UNITED STATES
NUCLEAR REGULATORY COMMISSION
WASHINGTON, D. C. 20555

MEMORANDUM FOR: Dr. Max Carbon, Chairman
Advisory Committee on Reactor Safeguards

SUBJECT: STATUS AND PROPOSED PLAN FOR RESOLUTION OF "ANTICIPATED
TRANSIENTS WITHOUT SCRAM" SAFETY ISSUE

ATWS - Outstanding ACRS Questions Following 227th Meeting - Applicable to
BWR's Only

Figure 1

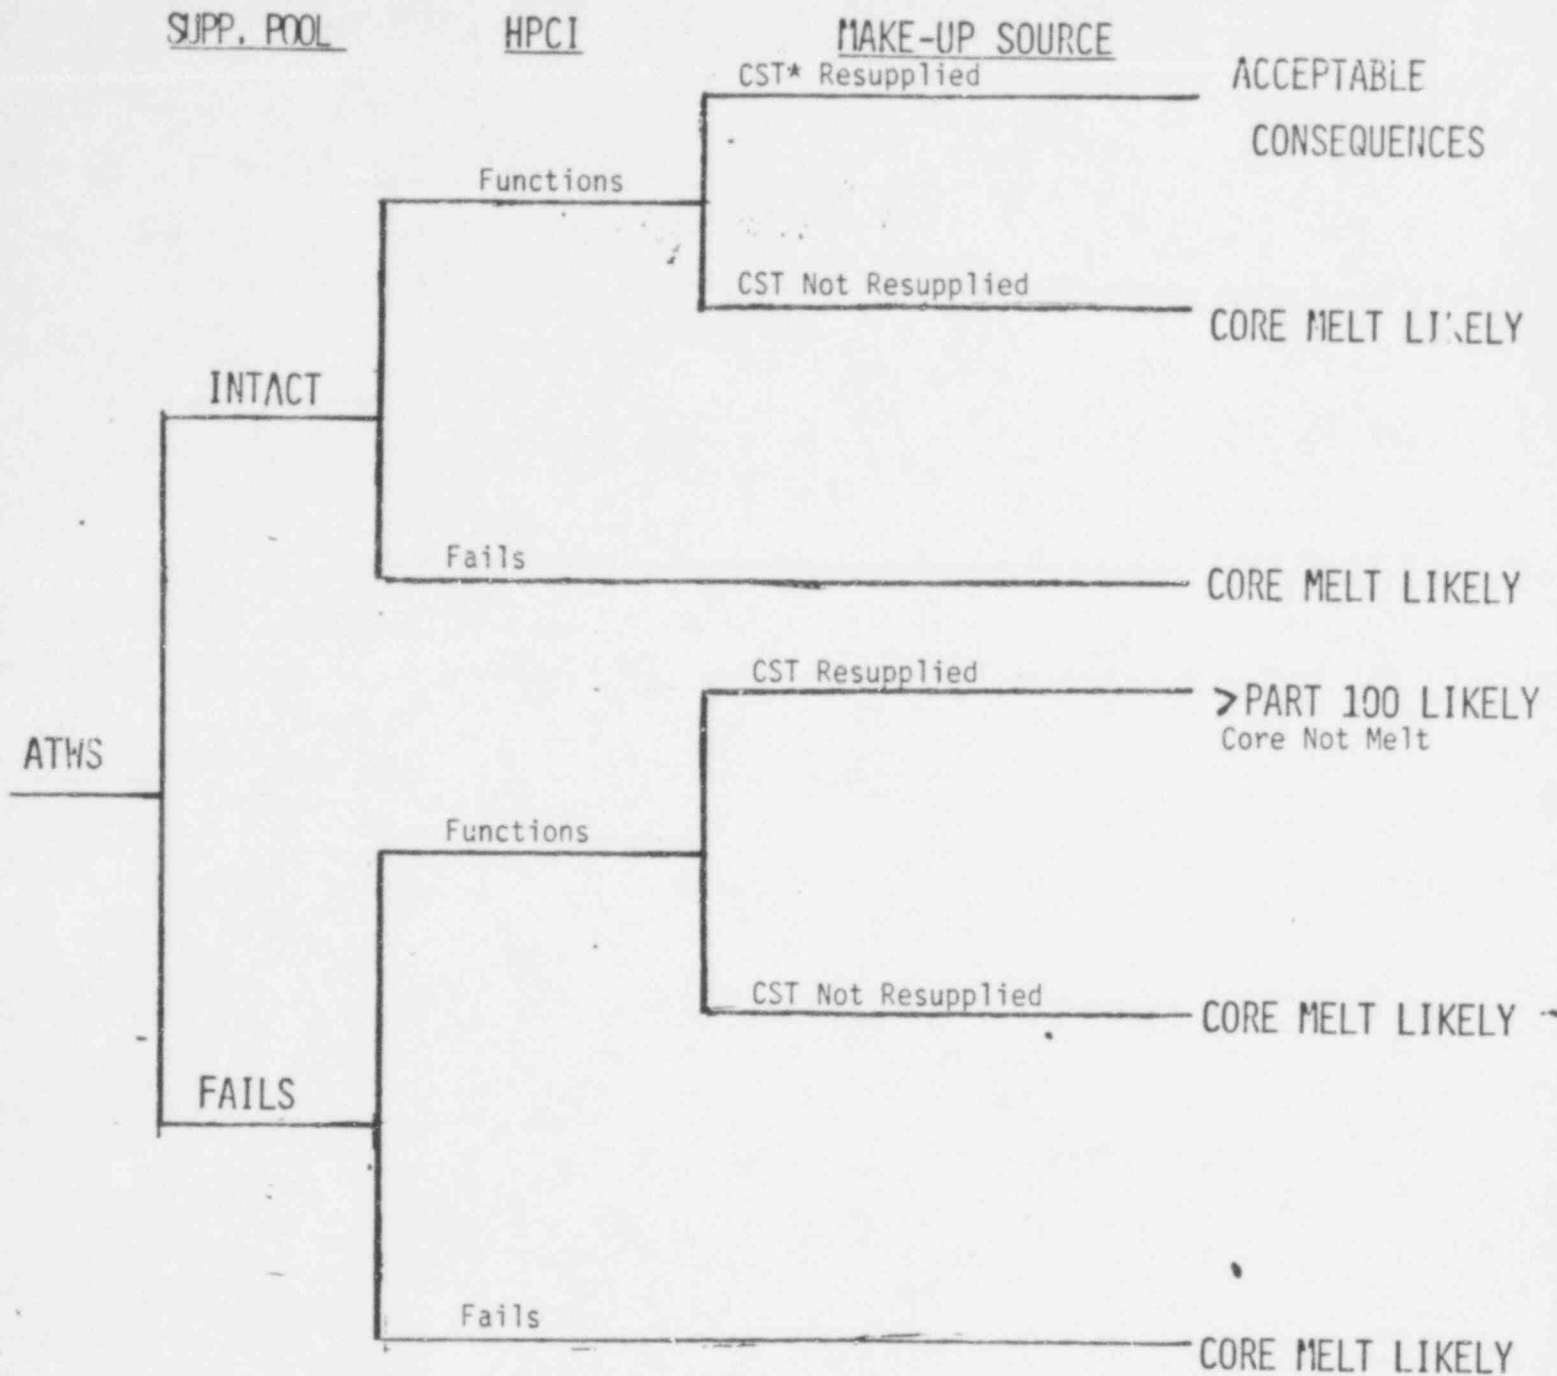
Current practice for operating BWR's is to restrict the allowable operating temperature of the suppression pool via the Technical Specifications such that the threshold temperature would not be reached in a Loss of Coolant Accident. Typical Technical Specification temperatures used for an operating Mark I plant are shown in Figure 1.
